STAFF REPORT: OCTOBER 11, 2023 MEETING

APPLICATION NUMBER: HDC2023-00043

ADDRESS: 4201 GLENDALE

SCOPE: *REPLACE WINDOW SASH, REMOVE TREE AND LANDSCAPING*

▪ **Figure 3: View of 4201 Glendale from Google Street View, 2022. The red arrow indicates the tree that was removed from the property by the applicant.**

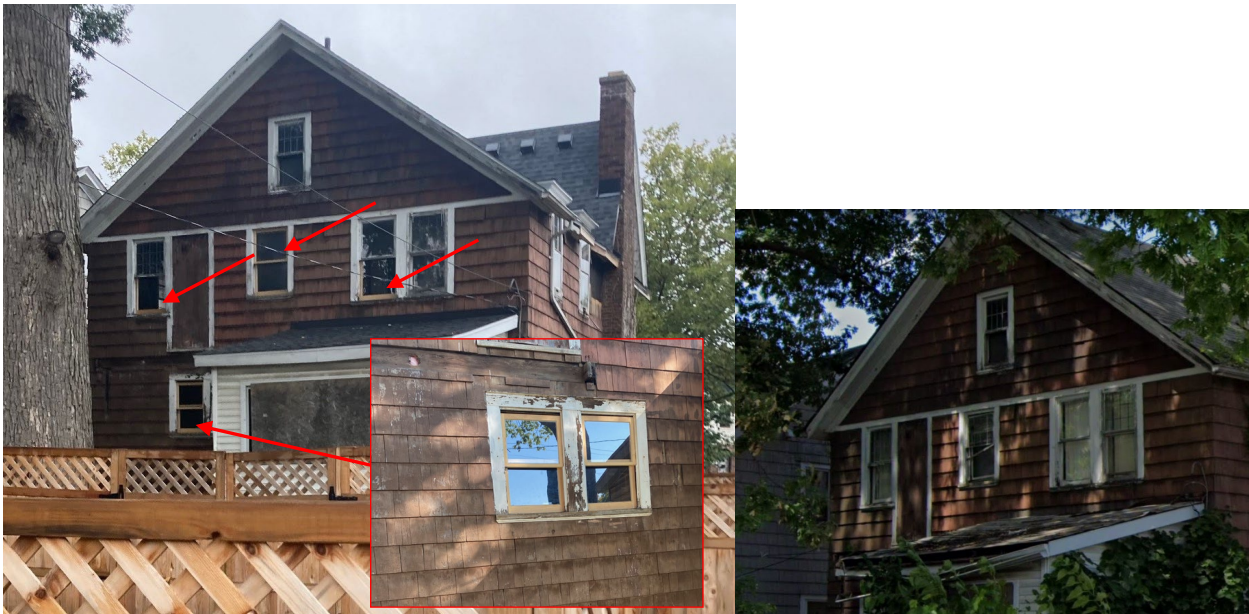
- The Russell Woods-Sullivan Historic District was established in 1999.
- In September, 2023, HDC staff issued a COA for work completed or in progress that included the following work items.
 - Replacement of front door
 - Rehabilitation of front porch
 - Installation of glass block windows at basement window openings
 - Repair of wood shingle siding in kind
 - Installation and staining of rear fence
 - Repair of fascia on board on house and garage
- Images available from Google Street View indicate that the mature tree removed by the applicant was diseased, leaning, overgrown for its location, and had the potential to cause damage to the foundation of the home.

Likewise, the foundation plantings and shrubs were overgrown and had the potential to damage the siding, chimney, and foundation.

- Available photographs show the shade tree was deteriorating, overgrown, and presented a threat to the historic dwelling. Likewise, the landscape plantings were overgrown and had the potential to damage historic materials on the dwelling. Staff recommends approval for this portion of the application.

Recommendation Two – COA – Removal of mature shade tree, landscape plantings, and replacement of lower window sash with new wood sash.

Staff finds that the proposal for the remaining work items will not alter the features and spaces that characterize the property and district and therefore recommends the Commission issue a Certificate of Appropriateness for the work as proposed as it meets the Secretary of the Interior's Standards and the Elements of Design for the district.
